DARDEN ARCHITECTS

Meeting date: December 6, 2019

PROJECT: 1843 RC Performing Arts Center

Design Development Project Update:

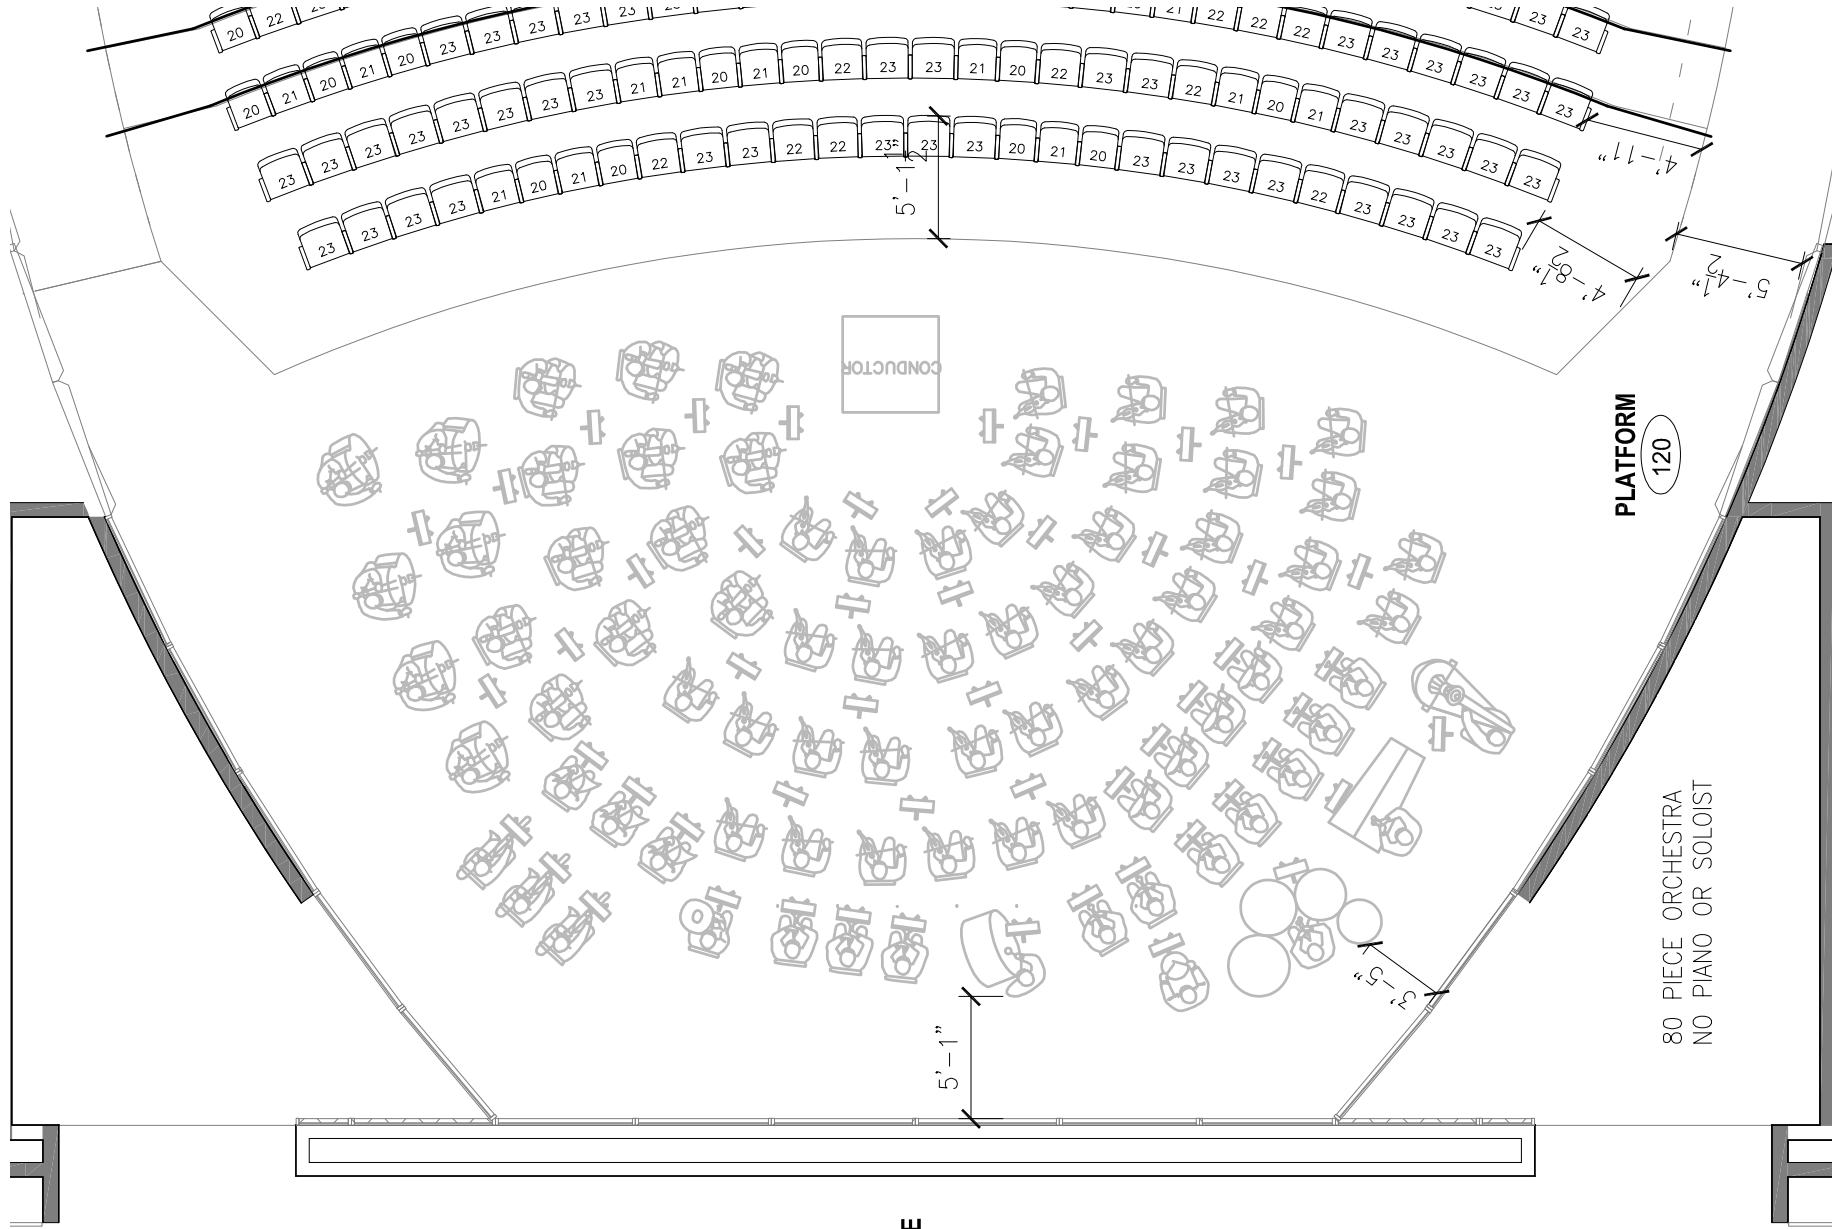
- 2.5.2. First 2 seating rows now at same grade and designated to be removeable. Provides for the following direction given during the 12/13/2018 meeting:

First Row 8'-10' from stage. This is for performers to 'surround' audience or have a small orchestra on floor. (2-4 people.) First row or 2 of chairs to be removeable to accommodate above without big empty space in front of audience at all times.

80 PIECE ORCHESTRA
NO PIANO OR SOLOIST

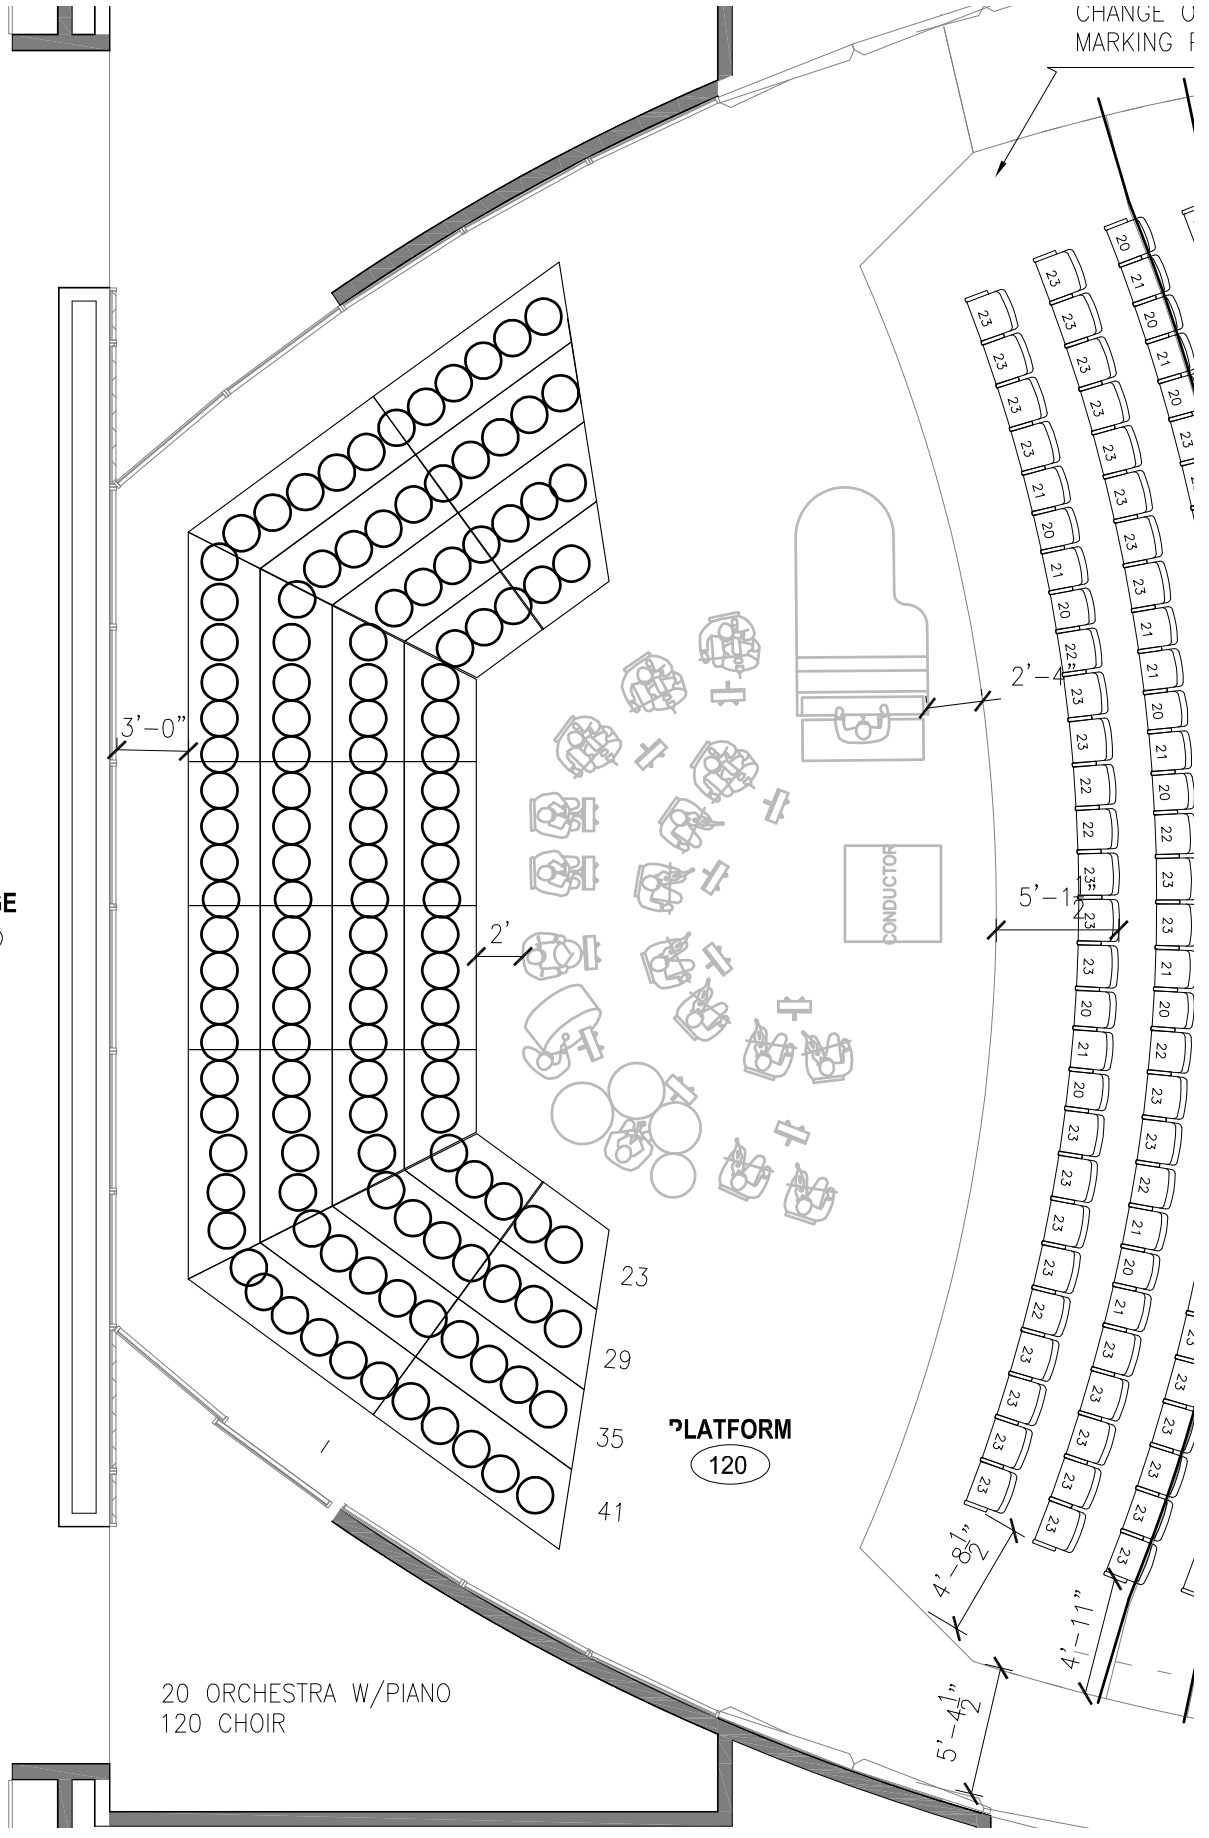
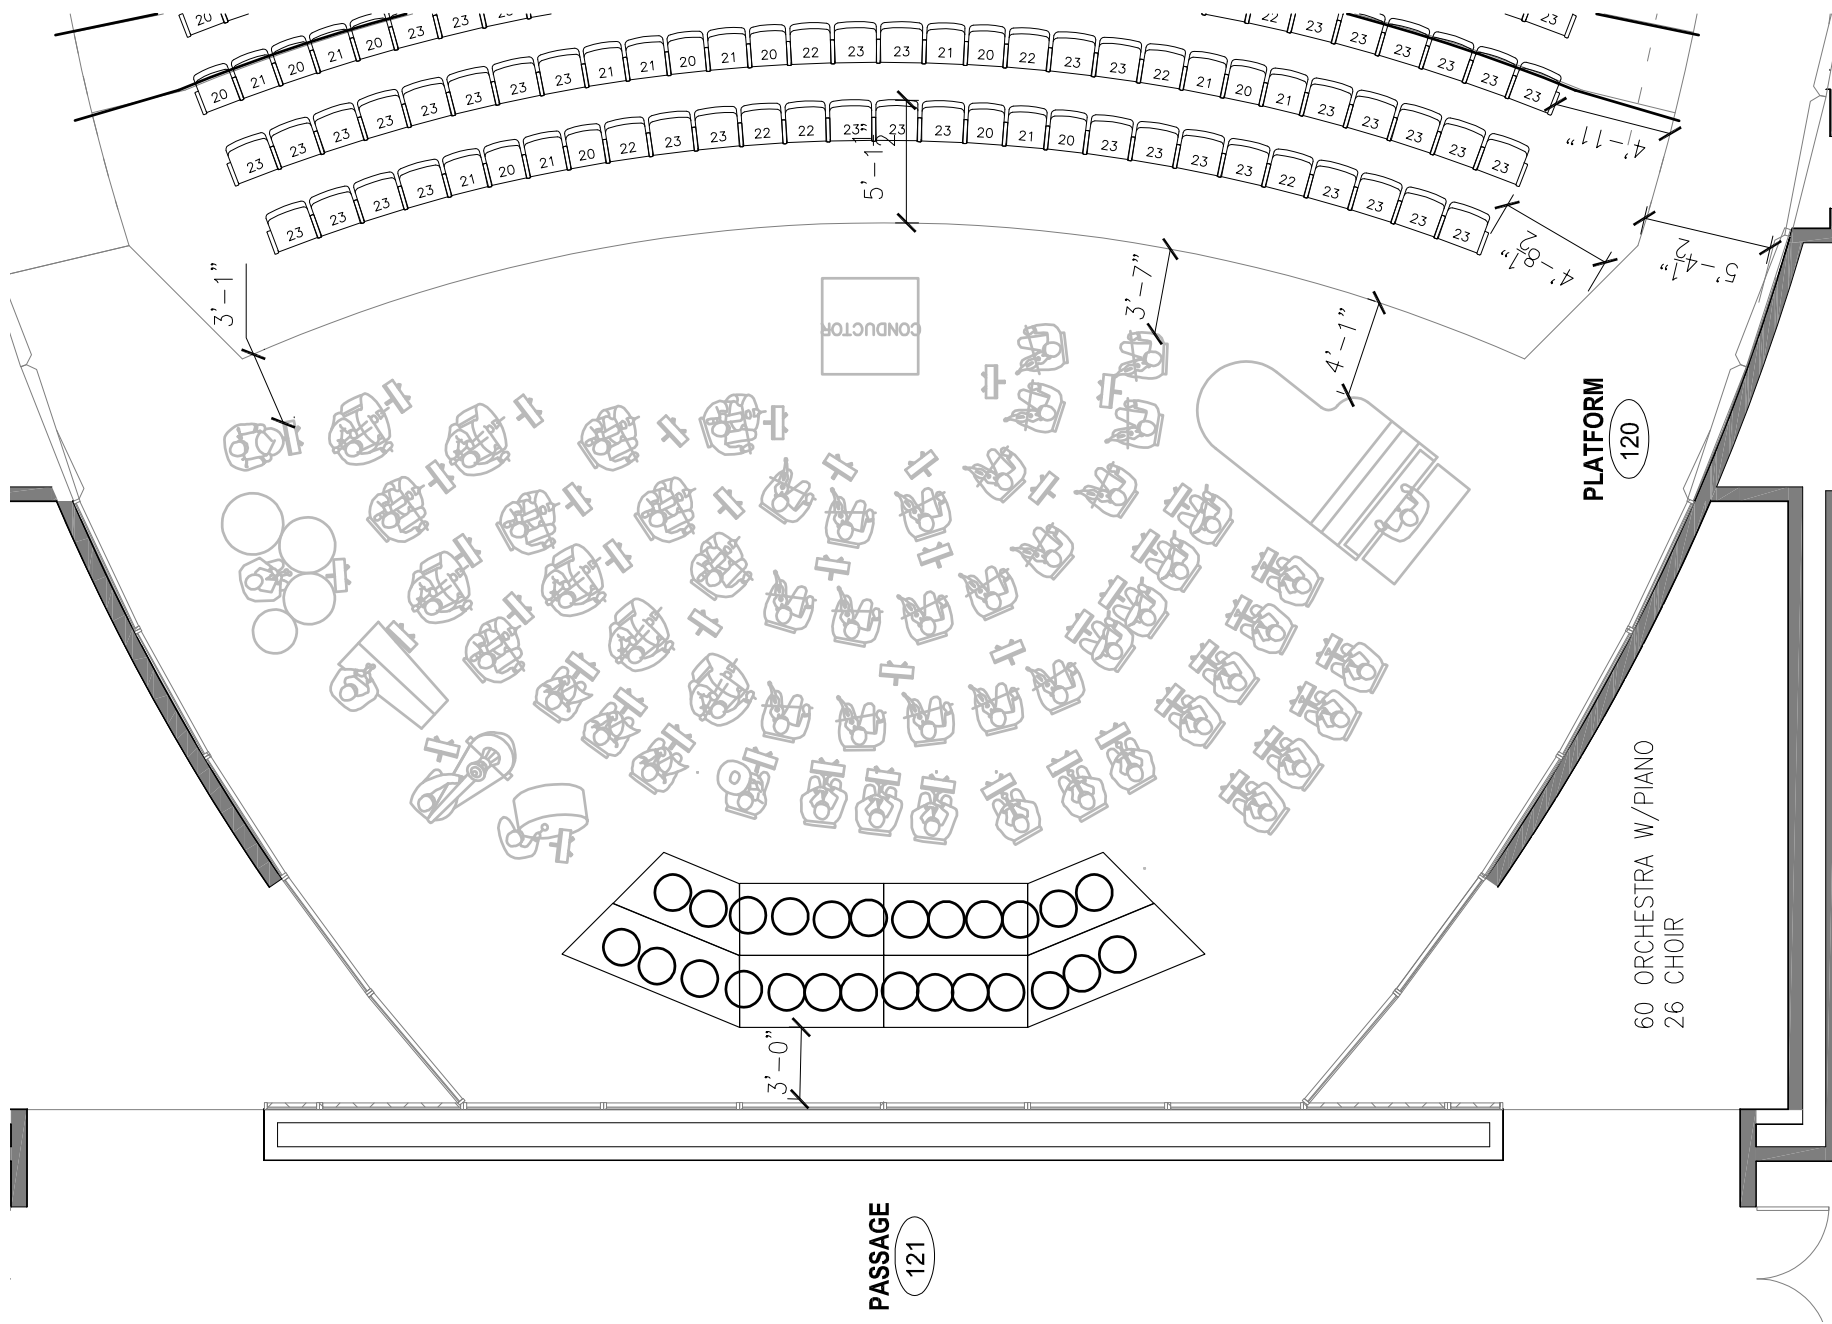
- 2.5.3. Platform (stage) size increased following an analysis of performer circulation and ensemble requirements. See attached platform ensemble layout concepts showing the following configurations

- 80-piece orchestra.
 - 60-piece orchestra w/piano and 26 choir.
 - 20-piece orchestra w/piano and 120 choir.
 - 2.5.4. Seat count 504 fixed seats w/ 6 wheelchair spaced (510 total).
